FINAL REPORT

SNOWDRIFT ASSESSMENT PROPOSED WASTEWATER LAGOON CLYDE RIVER, NUNAVUT

Project Number: 08-1023

February 29, 2008

APPENDIX A

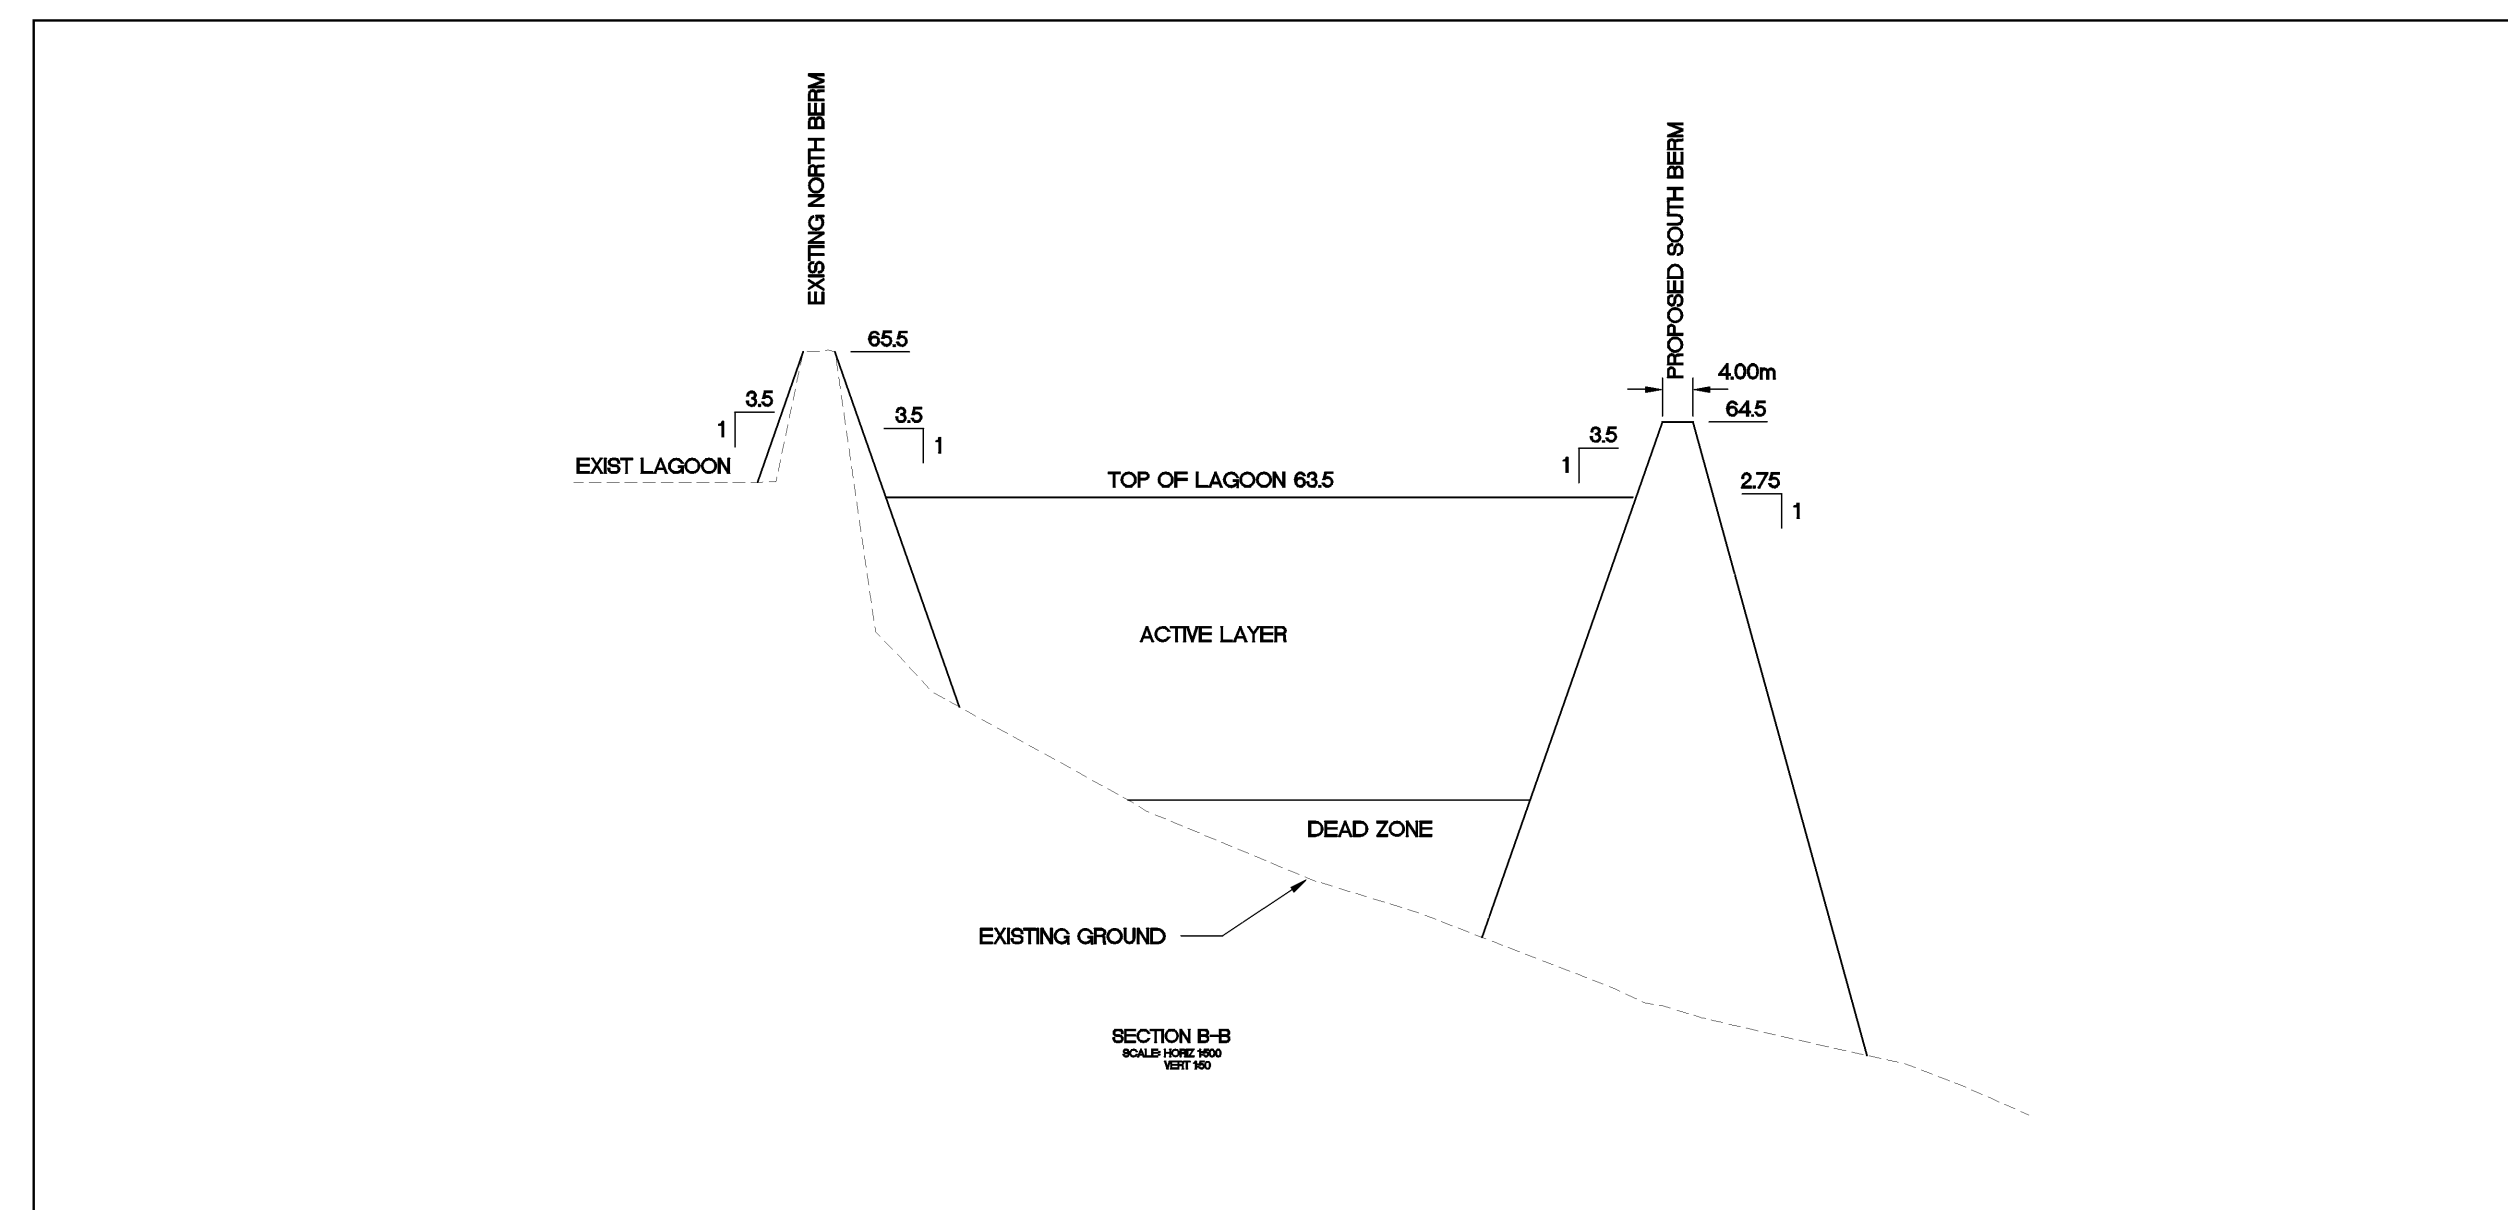
Assessment A (Refer to Appendix A) - The proposed wastewater lagoon is located adjacent to the existing lagoon west of the community. The sloped terrain in this area is not sufficient to create significant drifting problems. The site layout for the proposed lagoon shows a safety barrier along the edge of the existing lagoon as well as around the turn around and transfer area for the new lagoon. Large boulders will be used as safety barriers. Driver safety measures are essential, but it must be understood that the boulders will cause snowdrifts to form around them, and they will also impede snow removal operations. The Hamlet will use a front-end loader to remove snow from the lagoon area, as necessary. Snow should be dumped to the east side of the gravel pad to reduce the potential of the piled snow causing secondary drifting on top of the pad.

SCALE	N.T.S.	CLIENT:	GOVERNMENT OF NUNAVUT	JOB NO.	OTCD19055A
DATE:	17/01/08	TITLE:	CLYDE RIVER - ALTERNATIVE 1	FIG.5	
DRAWN:	MMR

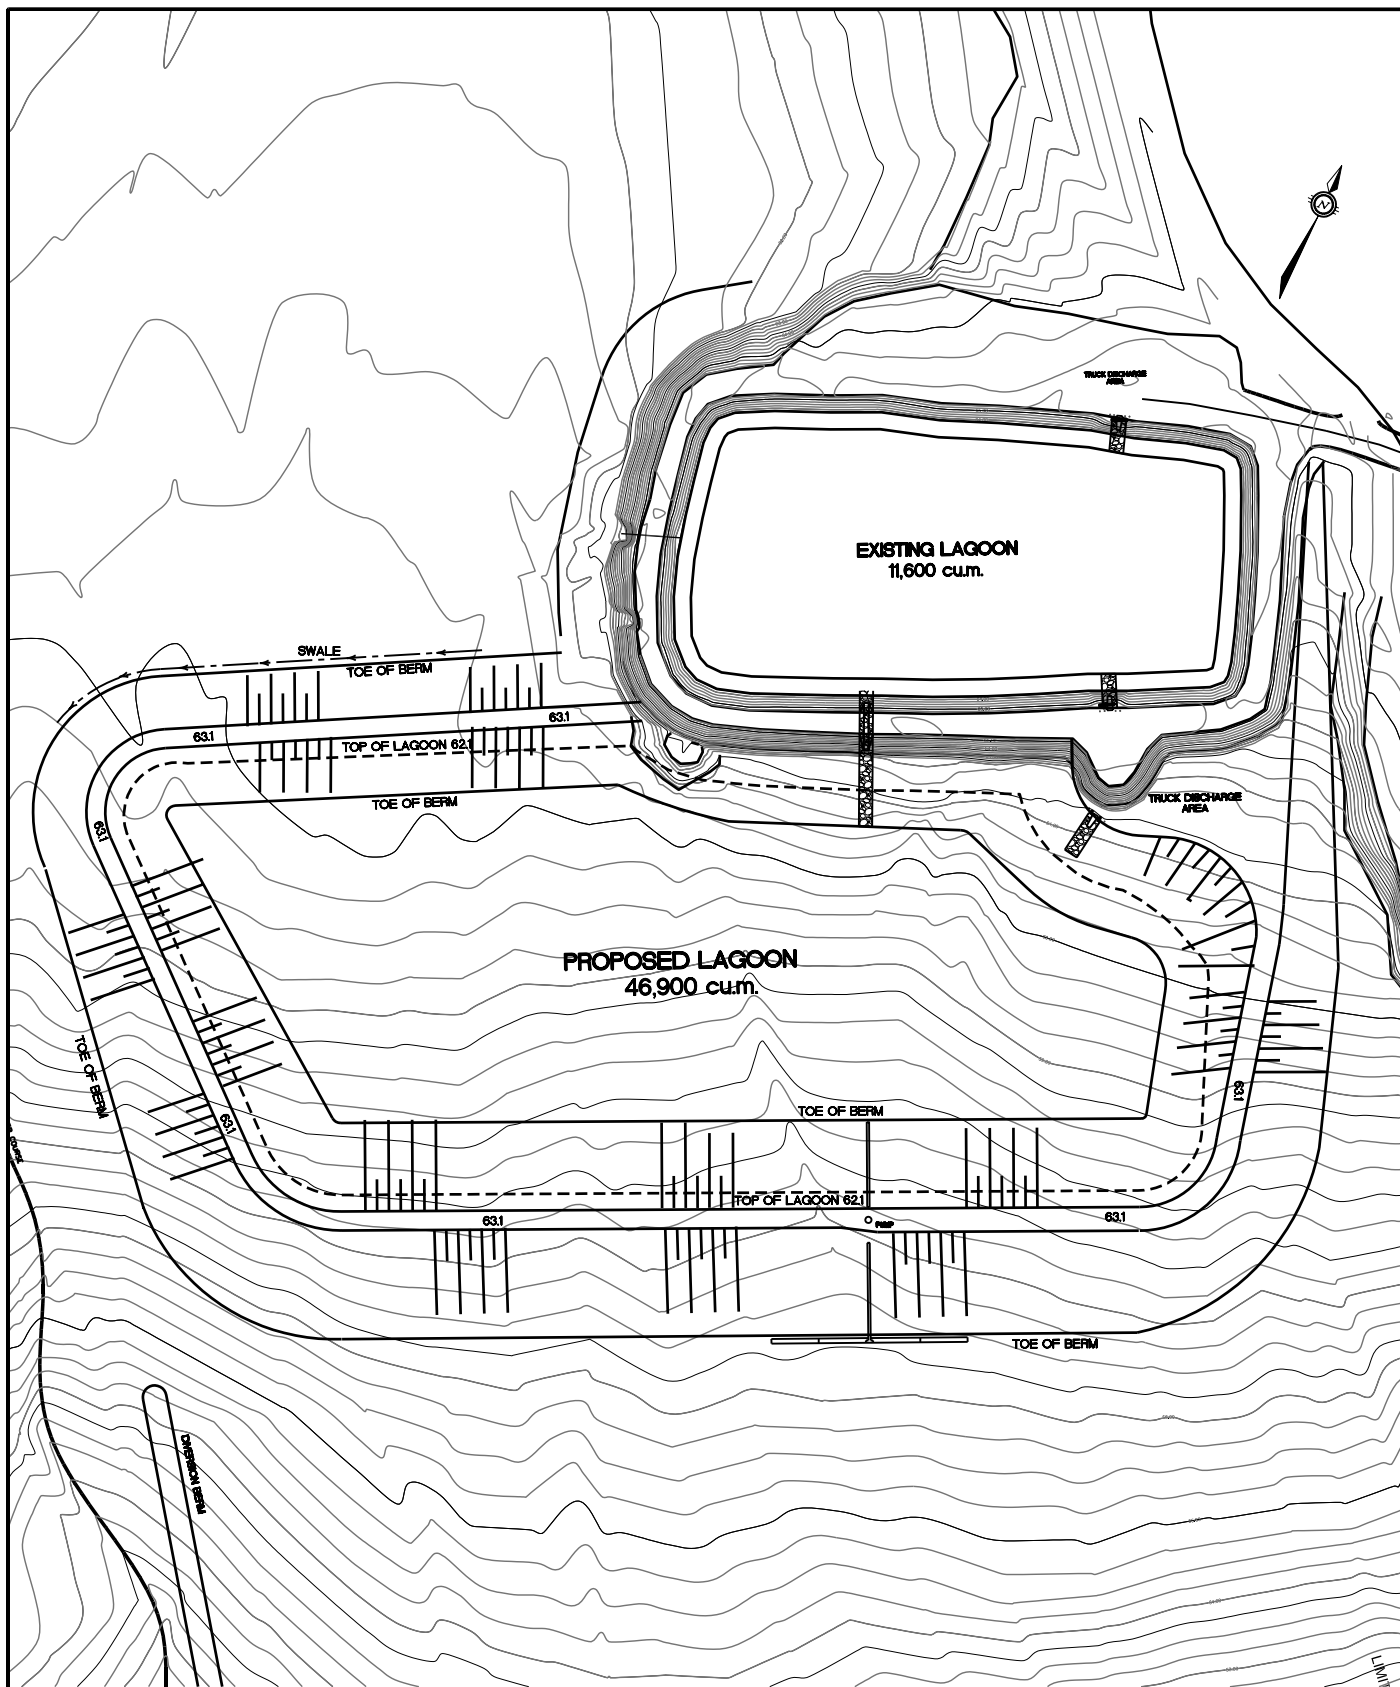
Assessment B (Refer to Appendix B) - From an overall snowdrift perspective, Alternatives 1 and 2 are the same (its understood that the berm height differs by 1m). In simple terms a taller embankment will collect slightly more snow within the lagoon, but mainly along northern edges of the lagoon. Because of the shallow sides slopes of the berm, the difference in stored/retained blowing snow will not be significant.

SCALE 1:1500	CLIENT: GOVERNMENT OF NUNAVUT	JOB NO. OTCD19055A
DATE: 17/01/08	TITLE: CLYDE RIVER - ALTERNATIVE 4	FIG.8
DRAWN: MMR

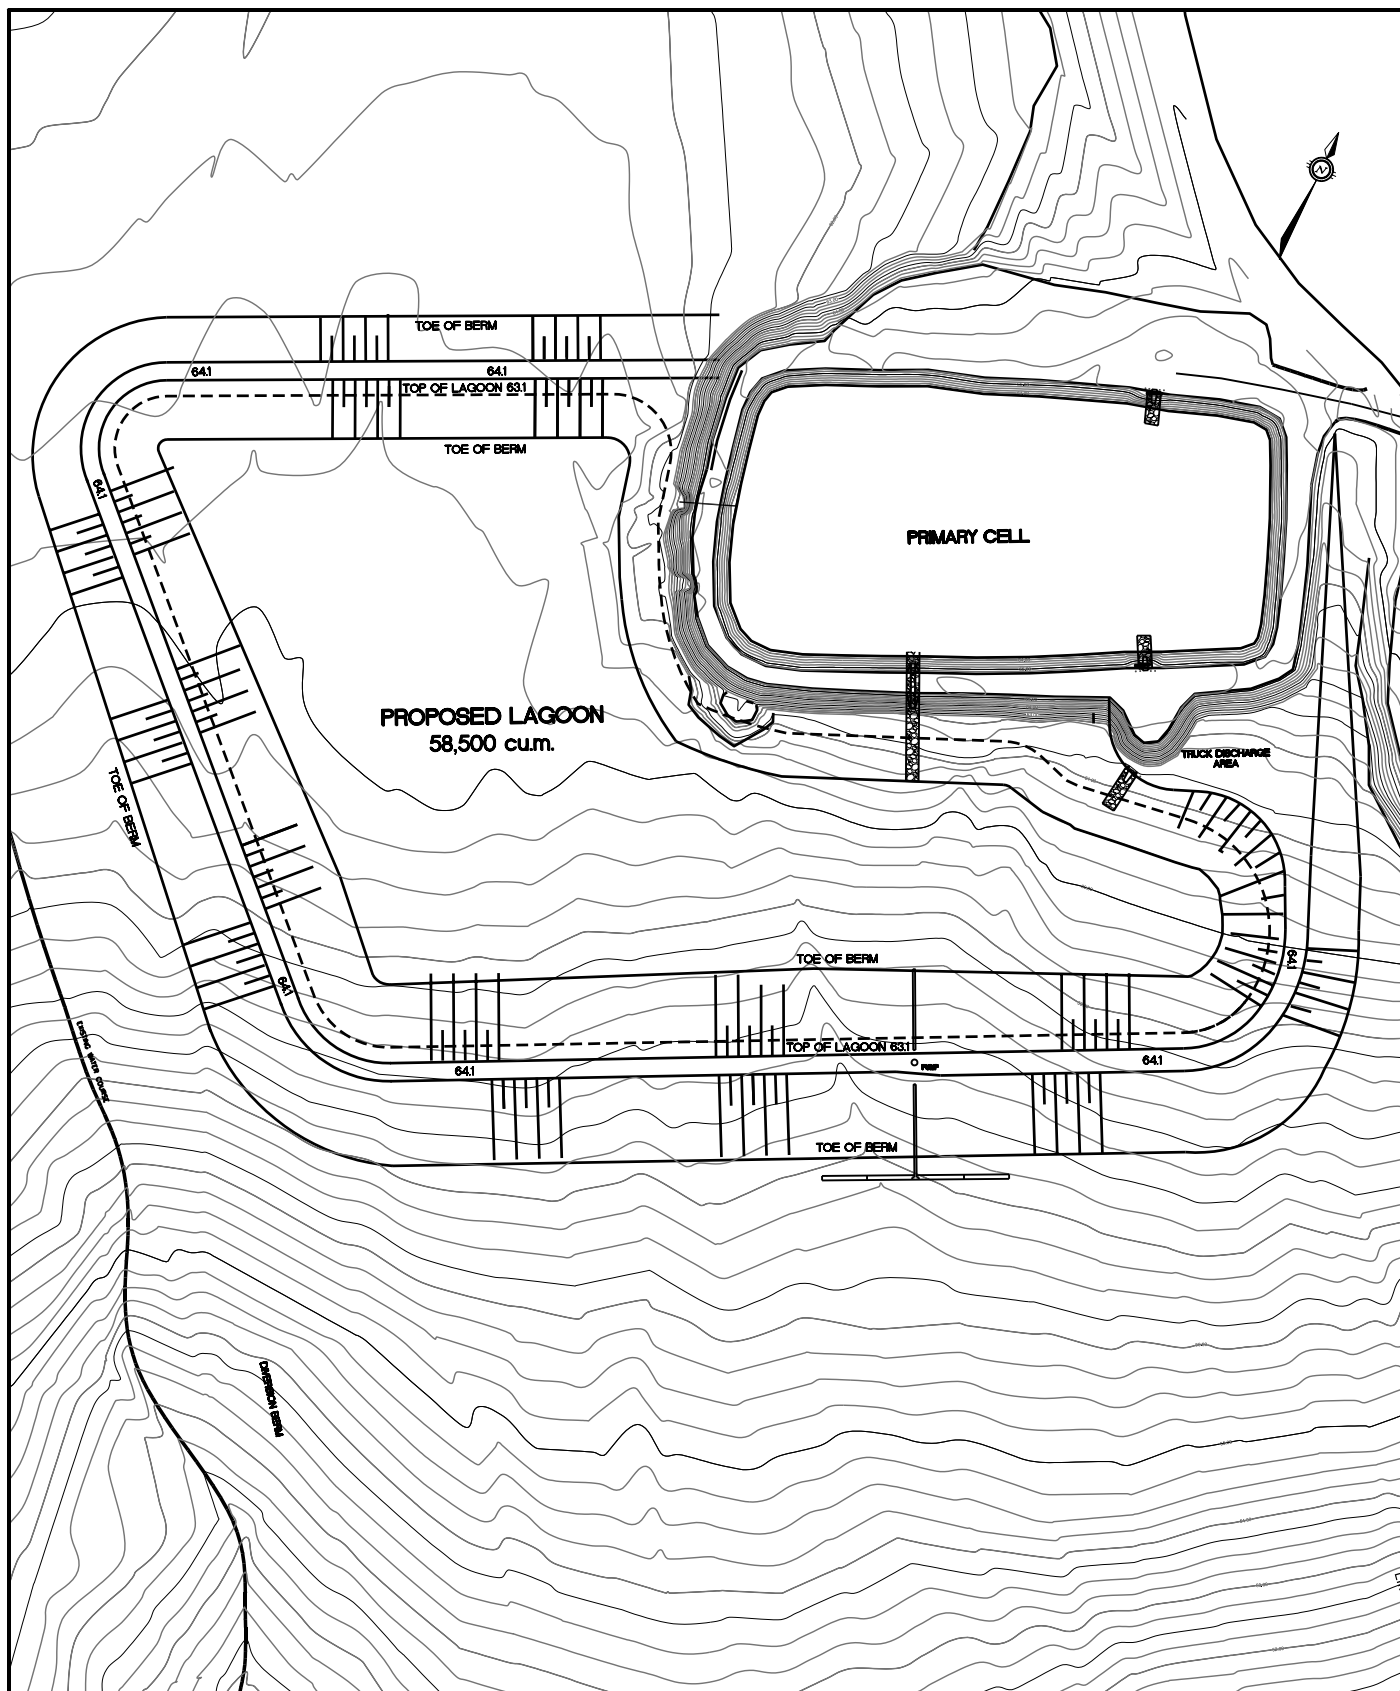
The main difference between Alternatives 3 and 4 is the presence of a second discharge point near the northwest "corner" of the existing lagoon in Alternative 4. The layout of the discharge area at the southeast "corner" of the existing lagoon is no different than the previous scheme we had reviewed, as per our final report you currently have. Those report comments would stand. The "northwest" discharge area is on the windward side of the lagoon. The safety barriers (e.g., boulders) are on the downwind (southeasterly) thus drifting on the traveled surface of the discharge area would be minimal.

Alternative 4 is the best scheme, where the northwest discharge area could be used mainly during the wintertime, therefore reducing the need for any significant snow removal in the area. The southeast discharge area could be left to drift in and used when weather permits. One could question if there is a need for the southeast discharge point at all?
